Meeting Notes

2022 California Energy Code (Title 24, Part 6)

Multifamily HVAC and Envelope

Meeting Date: March 25, 2020

Figure 7: Results of Poll 7, Single Answer

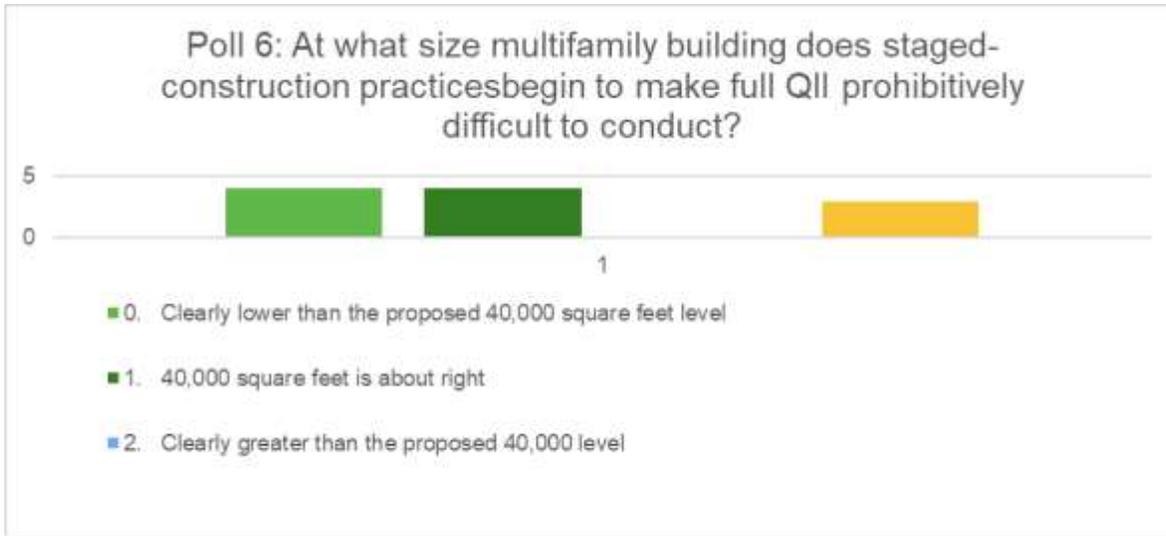
If Square footage generally should not be the basis, please share what should be:

1. Marina Chavez: Building height or number of stories.
2. Cassandra Trester (Ei Companies): Number of stories.

Figure 8: Results of Poll 8, Single Answer

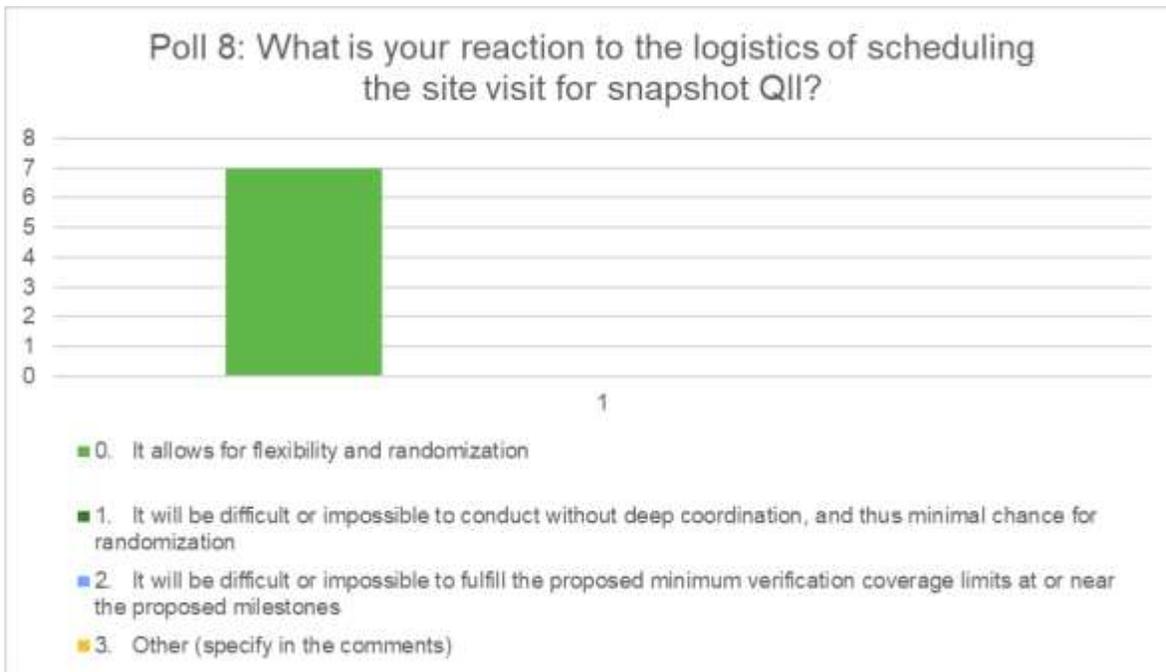
1. Cassandra Trester (Ei Companies): There is never being ready... this is in the top two failures of inspections.
